**foundation
investigation and
design report**

Hwy. 407 and Hwy. 50 Underpass

FOUNDATION INVESTIGATION REPORT

Hwy. 407 and Hwy. 50 Underpass
W.P. ^{369-87-09/10} ~~367-87-02~~, Site No. 37-1334
Hwy. 407, District 6, Toronto

HWY 50 UNDERPASS AT
HWY 407

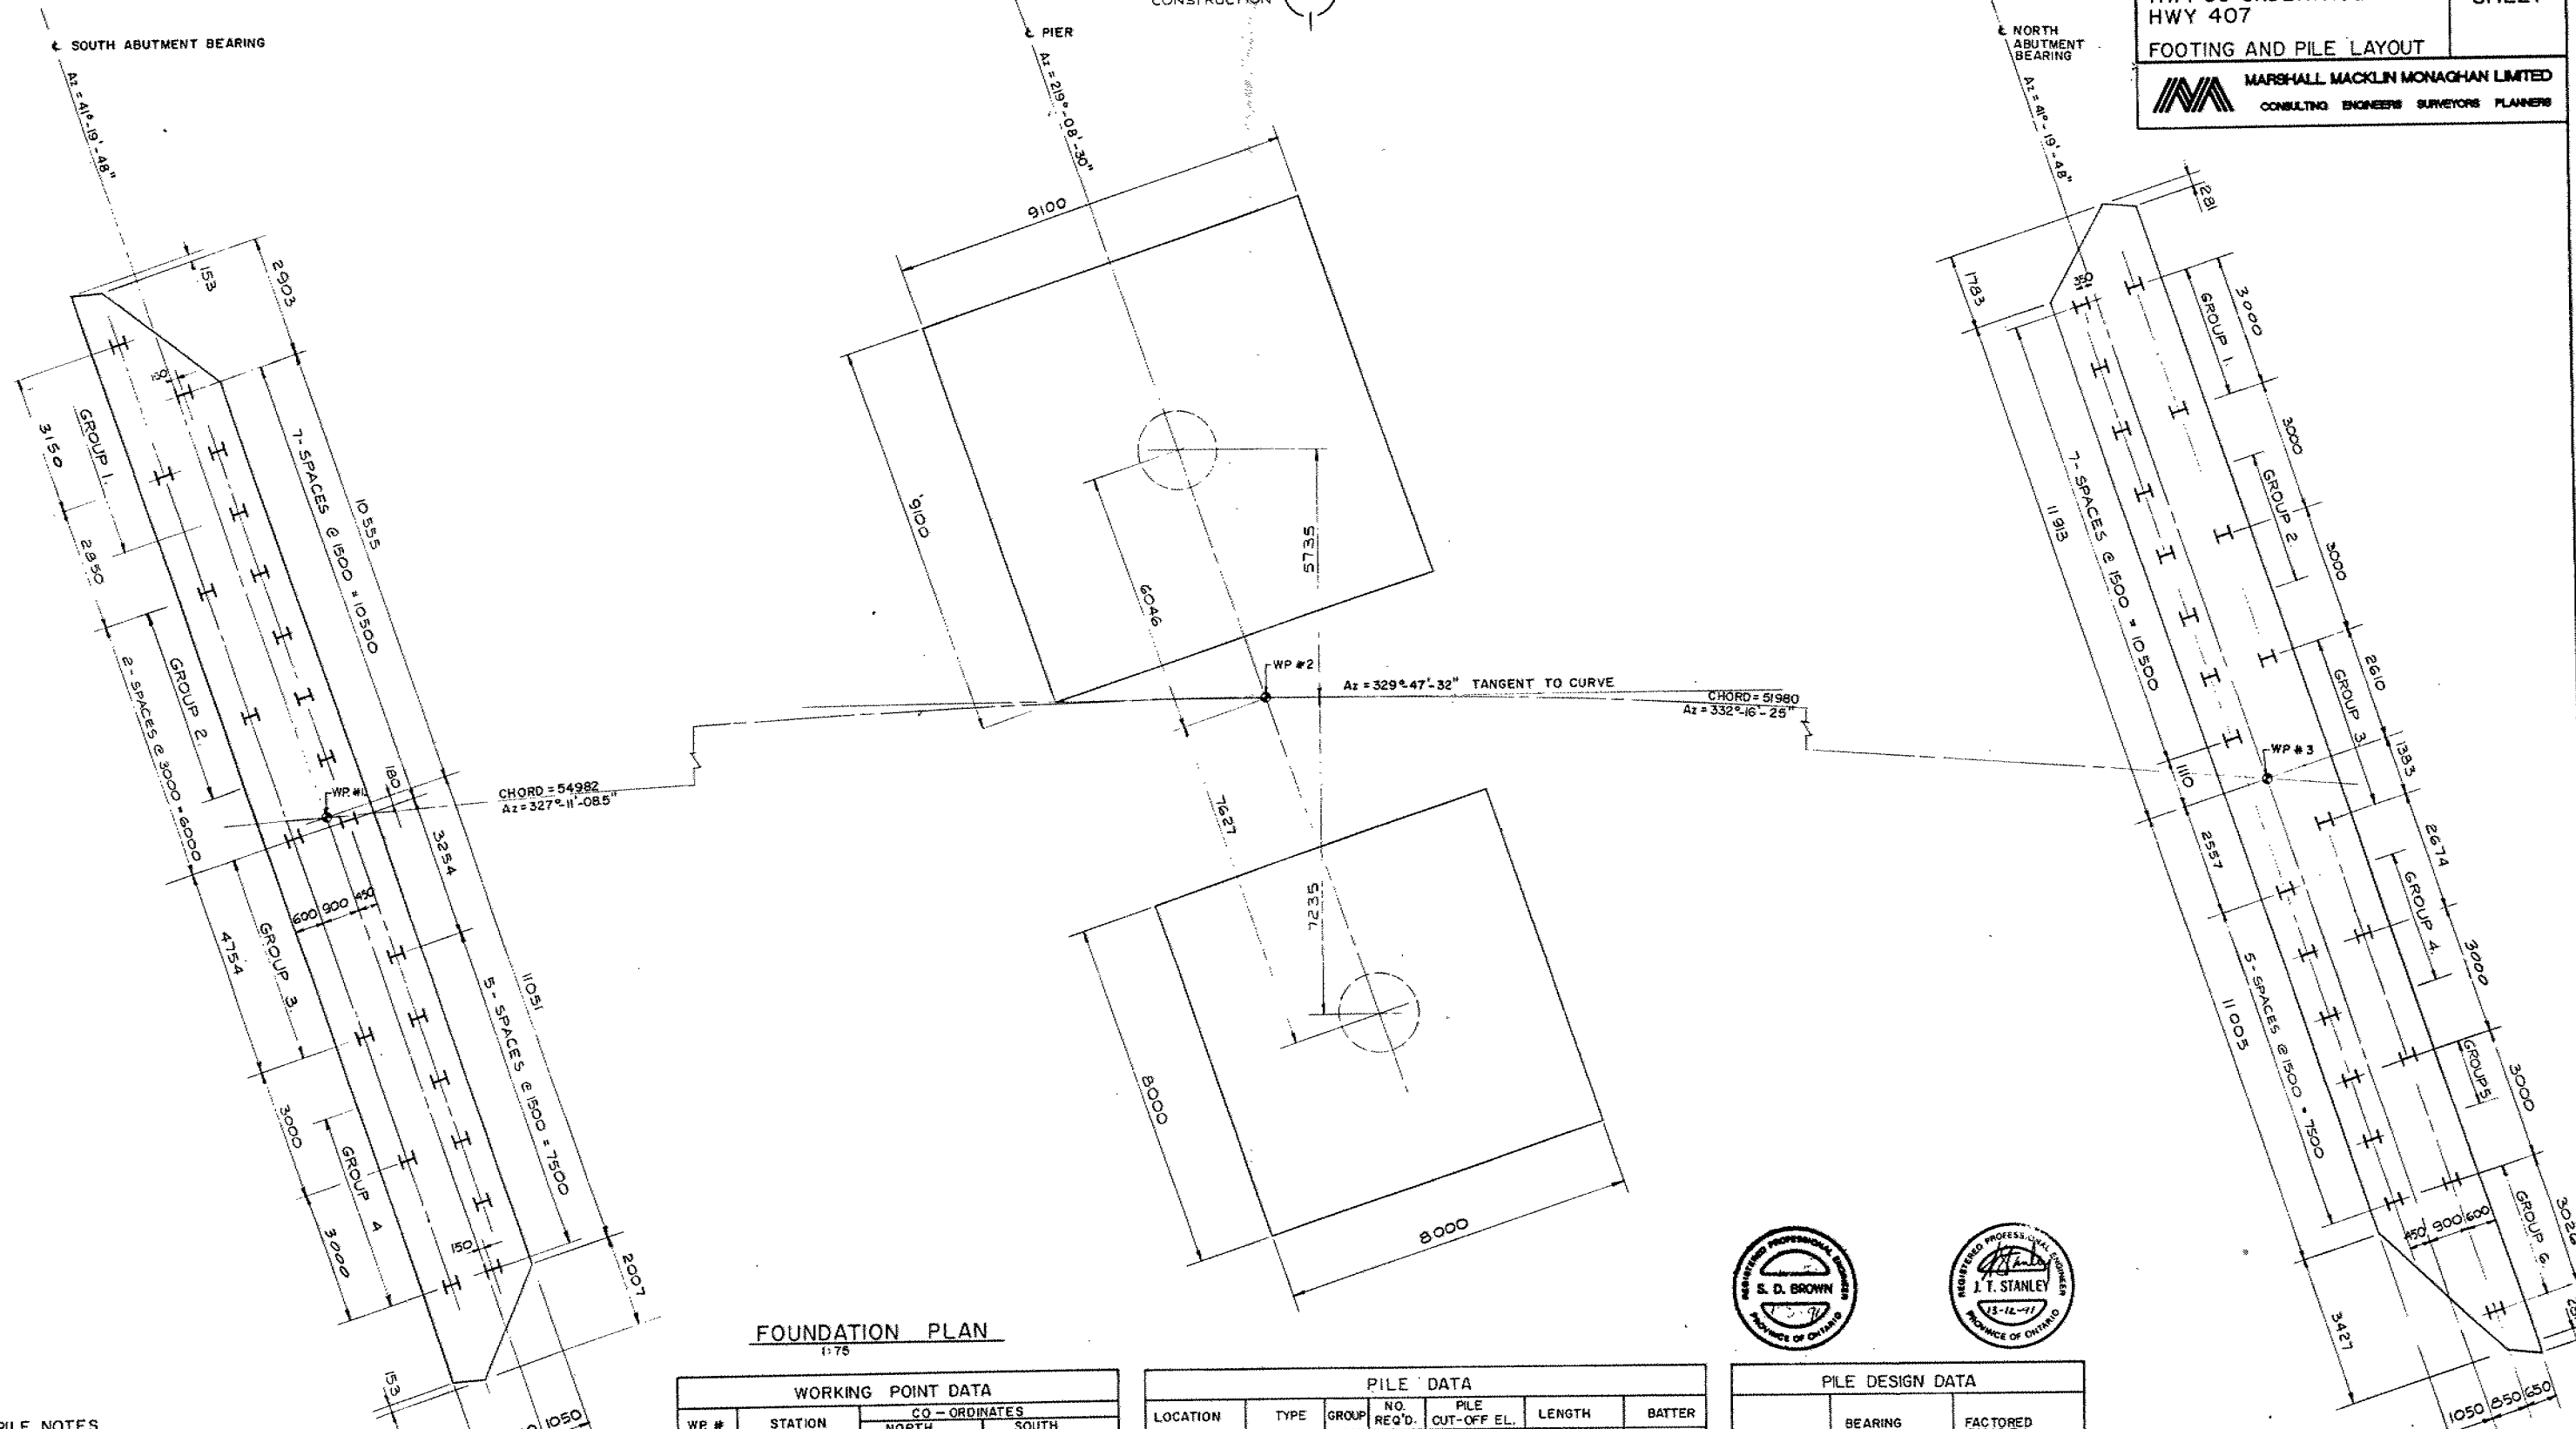
1. On the General Arrangement drawing, remove the following phrases:
 - i "..... driven to El. 161.000." (from the south abutment area)
 - ii "..... driven to El. 164.000." (from the north abutment area)
2. On drawing No. 3, make the following changes:
 - i All piles shall have standard MTO pile tip reinforcement as per DD 3301.
 - ii Change the ultimate capacity of piles to 3450 kN, from 5450 kN.
 - iii Remove the phrase "... but not below elevation shown on Drawing 1, without the approval of the engineer.
3. There are two existing CSP's, one at the north abutment area and the other at the south abutment area. We assume that protection of these existing culverts during the construction of the bridge is covered elsewhere.

- The location of the C.S.P. does not affect the piled abutment footings.
- At North Abutment the pile tip elevation (El. 169.0 m \pm) will be lowered. The revised tip elevations will vary from El. 164.0 m \pm to El. 167.0 m \pm to stabilize the piles.
- The following construction sequence will apply:
 1. Excavation for Highway 407.
 2. Excavation and installation of C.S.P.
 3. Construction of abutment piles/footings.
 4. Construction of Reinforced Earth wall in front of the abutments.

CONT No	369-87-09 (NB)
WP No	369-87-10 (SB)
HWY 50 UNDERPASS AT HWY 407 SOUTH ABUTMENT

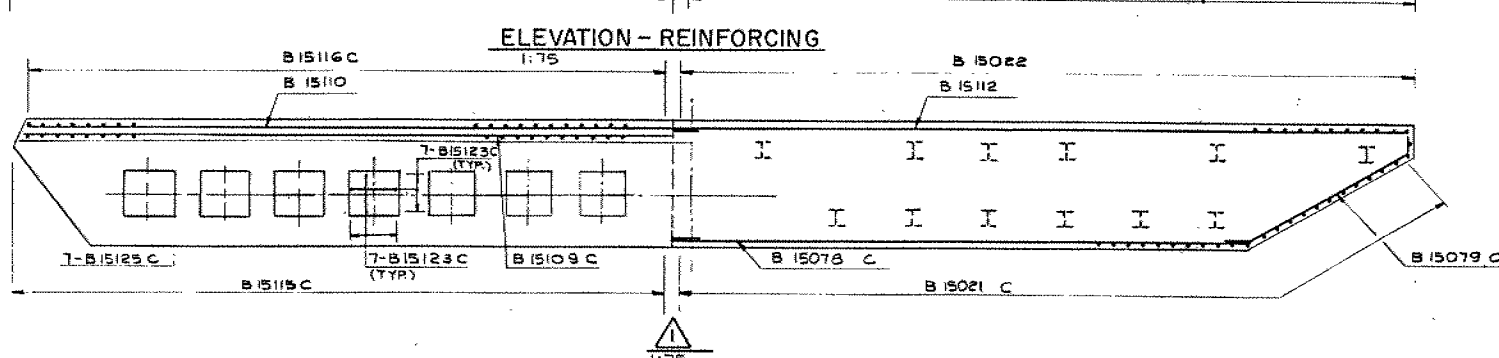
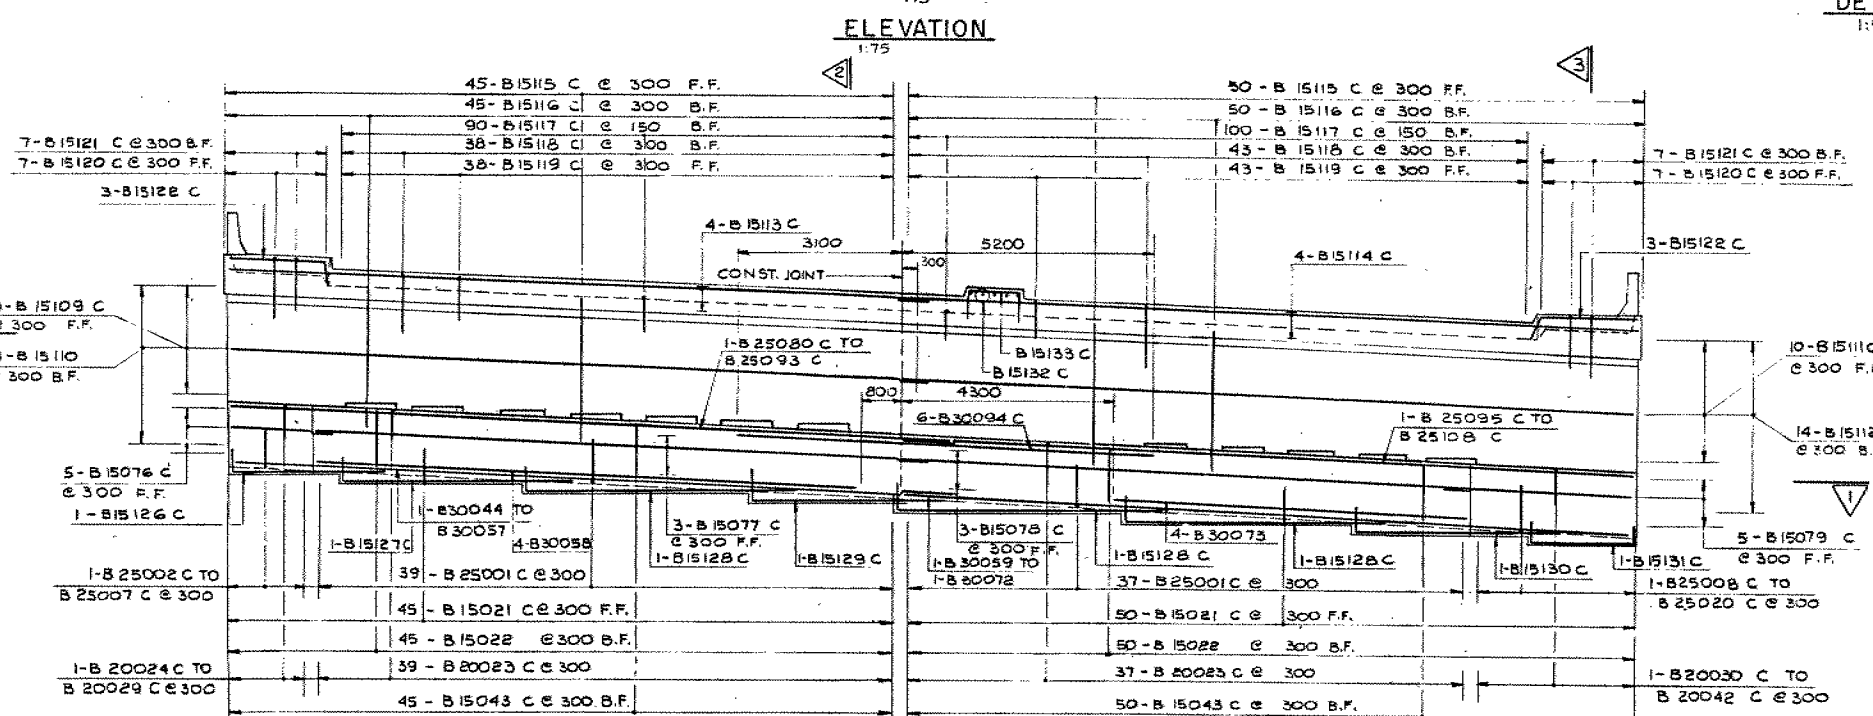
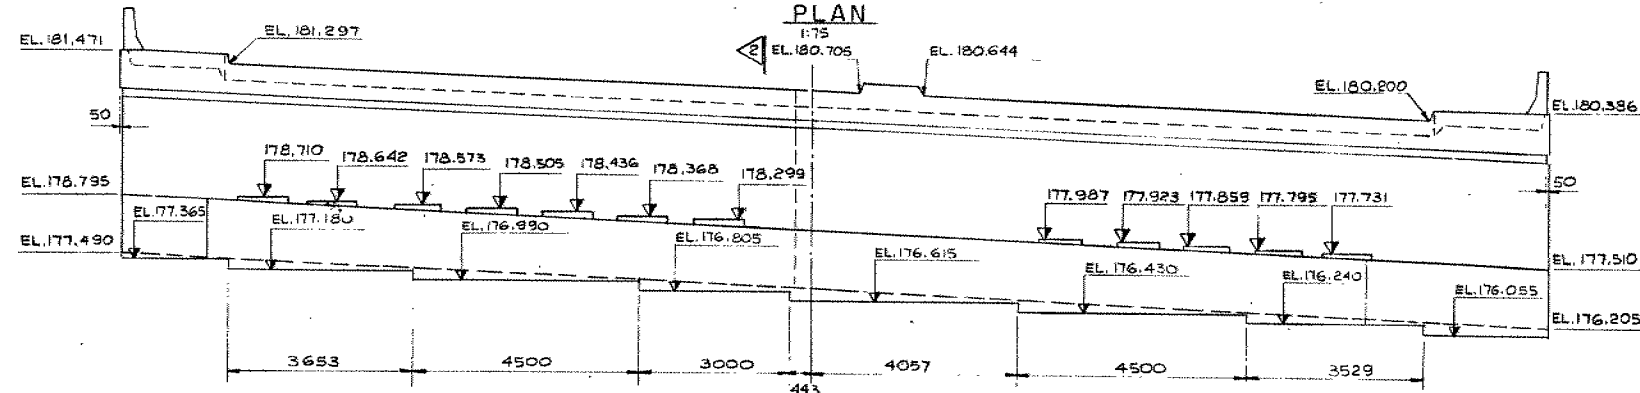
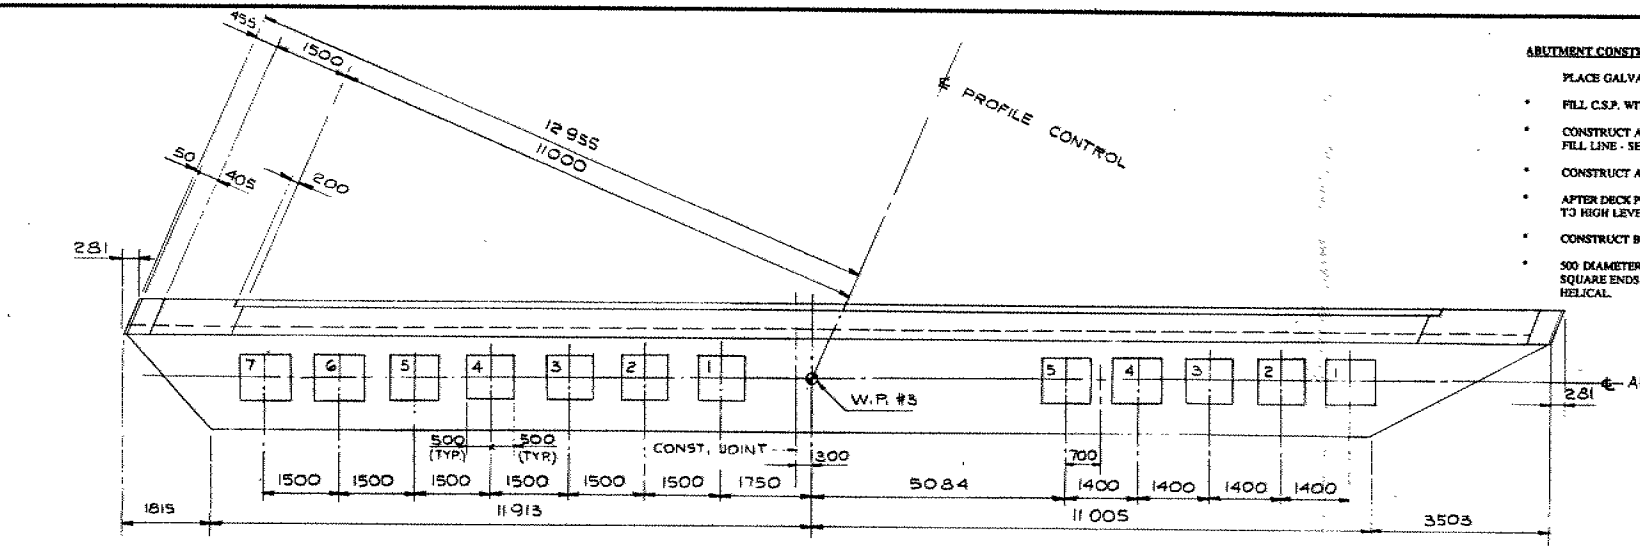
*we have no detail
to interpret elev
so they need profile
to top of pier
they should have
used referenced material
we shouldn't have to
search our files for.*
